**SUBDIVISION &  
PLANNED UNIT DEVELOPMENT  
STAFF REPORT**

**Date: January 5, 2023**

**DEVELOPMENT NAME** Leighton Village

**SUBDIVISION NAME** Leighton Place Subdivision, Phase II

# SITE PLAN

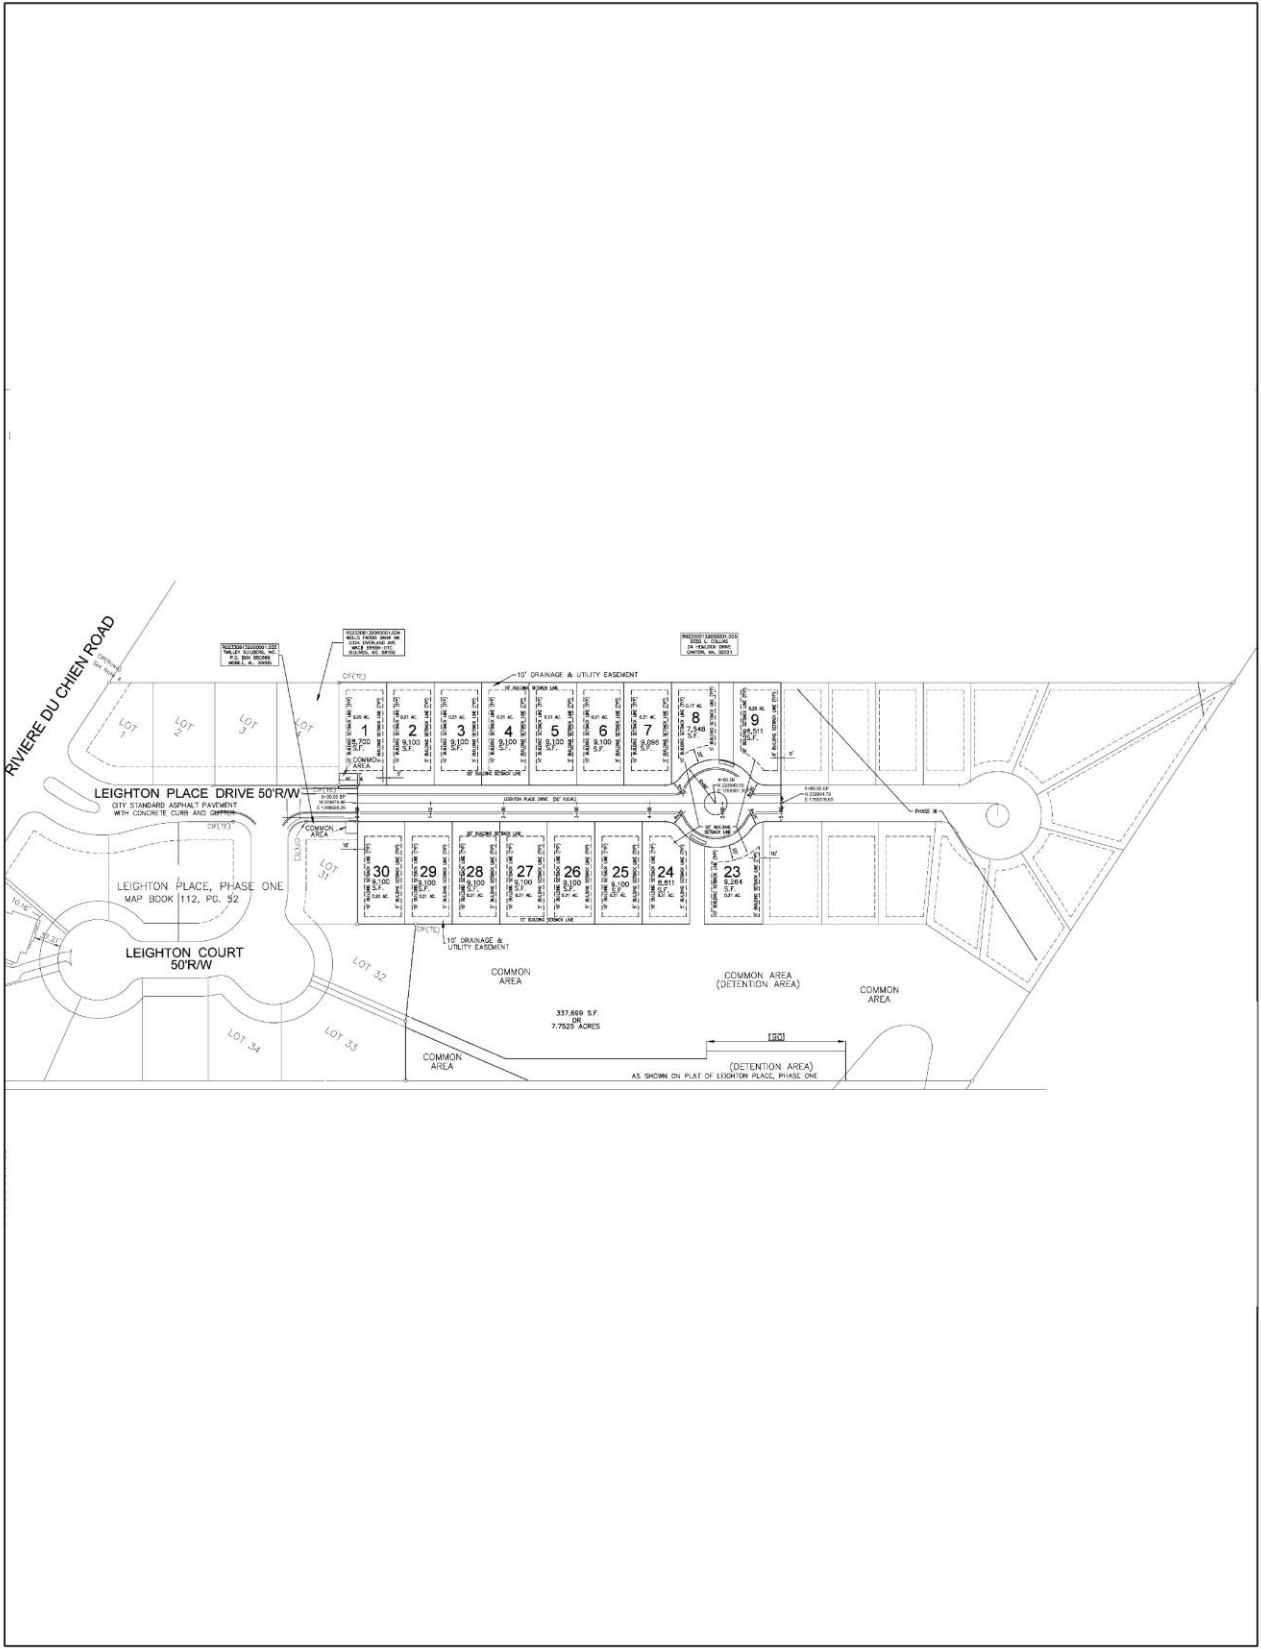
**Planned Unit Development:** Retain NOTES #1 - #8, as shown on the LEIGHTON VILLAGE PUD PLAN drawing SHEET 1 of 1.

Again, other than reversing the side yard setbacks, the site plan submitted is almost a copy of the preliminary plat and site plan approved with the October, 2021 PUD. The right-of-way width of Leighton Place Drive should be retained on the site plan. The lot size labels in both square feet and acres should be retained on the site plan, or a table should be furnished on the site plan providing the same information. The lots are labeled with the proposed setback data and this should be retained on the site plan, or a table should be furnished on the site plan providing the same information. The note on the site plan stating that the maximum site coverage on all lots shall not exceed 40% should be retained on the site plan.

The note on the site plan stating that the maintenance of all Common Areas is the responsibility of the property owners and not the City of Mobile should be retained on the site plan. The note on the site plan stating that no structure may be constructed or placed within any easement without permission of the easement holder should be retained. The site plan should be revised to indicate a City-standard public sidewalk along both sides of the proposed street within the right-of-way.

- 7) revision of the site plan to indicate a City-standard public sidewalk along both sides of the proposed street within the right-of-way;
- 8) compliance with the Engineering comments: *(Retain NOTES #1 - #8, as shown on the LEIGHTON VILLAGE PUD PLAN drawing SHEET 1 of 1.);*

- 1) retention of the right-of-way width of Leighton Place Drive on the site plan;
- 2) retention of the lot size labels in both square feet and acres on the site plan, or the furnishing of a table on the site plan providing the same information;

- 3) retention of the setback data labels on the individual lots, or the furnishing of a table on the site plan providing the same information;
- 4) retention of the note on the site plan stating that the maximum site coverage on all lots shall not exceed 40%;

- 5) retention of the note on the site plan stating that the maintenance of all Common Areas is the responsibility of the property owners and not the City of Mobile;

- 6) retention of the note on the site plan stating that no structure may be constructed or placed within any easement without permission of the easement holder;
